Spartan Motors

CSB99-1201

CAMPAIGN SERVICE BULLETIN

SUBJECT: Fire Truck Cab Tilt Release Function

FIG. 6-1

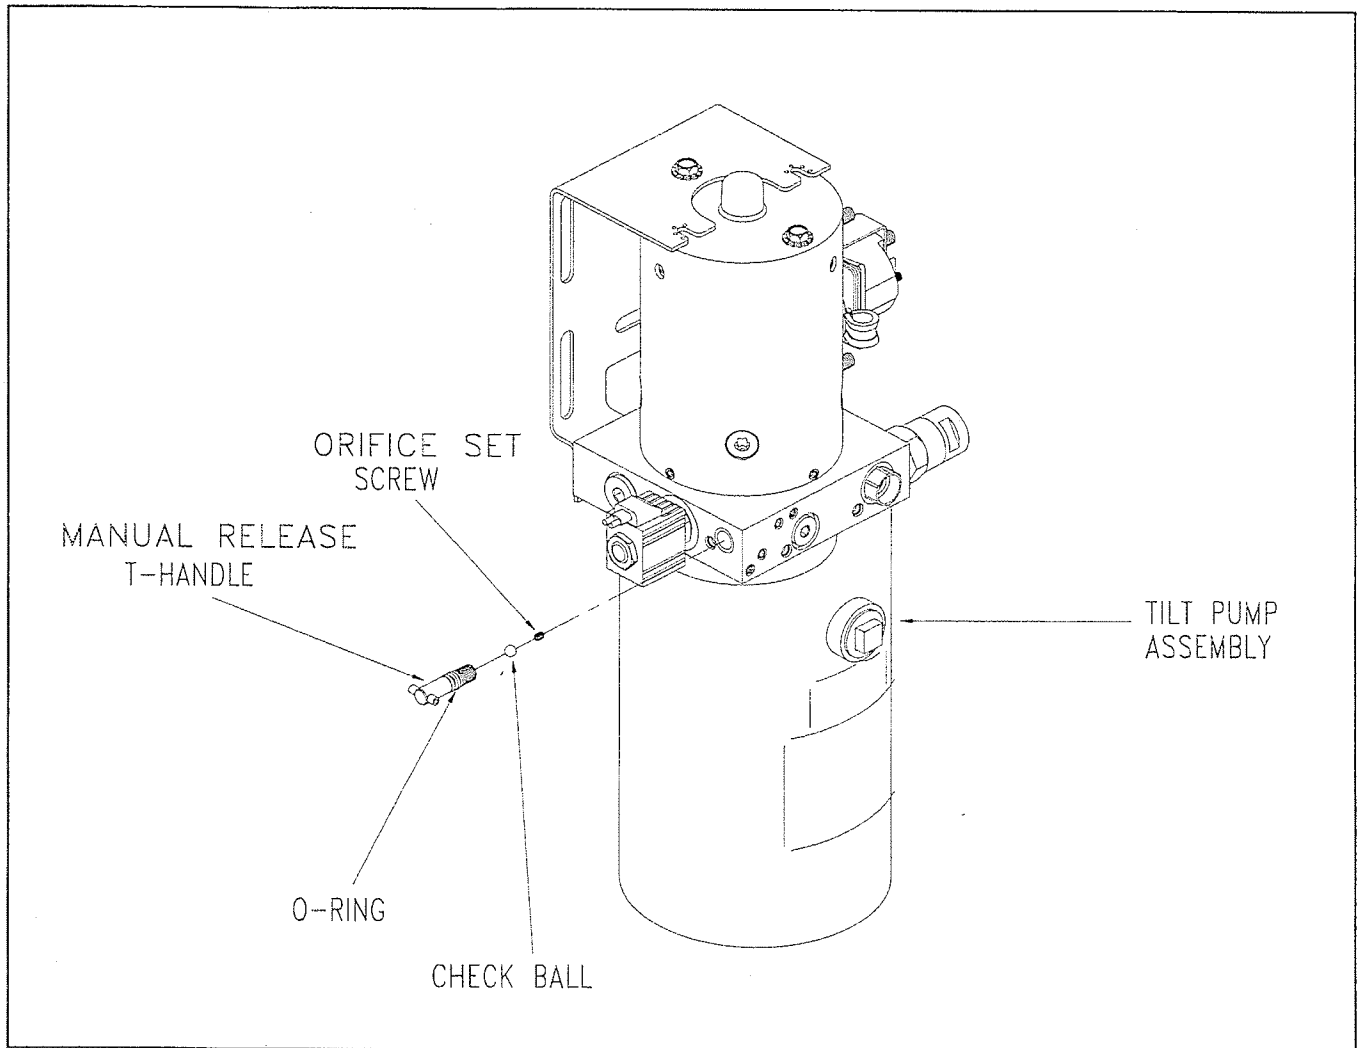
Missing Orifice In the Hand Pump Circuit

9A. Refer to FIG, 6-1. Remove the T-handle and check ball. Insert a magnetic tool into the port opening to locate and remove the check ball (resembles a stainless steel ball bearing).

9B. Using a #2 metric hex key wrench, locate orifice set screw inside of the tilt pump assembly.

9C. Remove the orifice set screw and inspect/clean debris from orifice.

Install Missing Orifice

13. Insert a magnetic tool into the port opening to locate and remove the check ball (resembles a stainless steel ball bearing).
14. With the check ball removed, use a #2 metric hex key wrench to install the orifice set screw provided; fully seat.
15. Ref to FIG. 6-1. With the orifice set screw in place, reinstall the check ball into the port.
16. Reinstall T-handle into the port until it is fully seated.
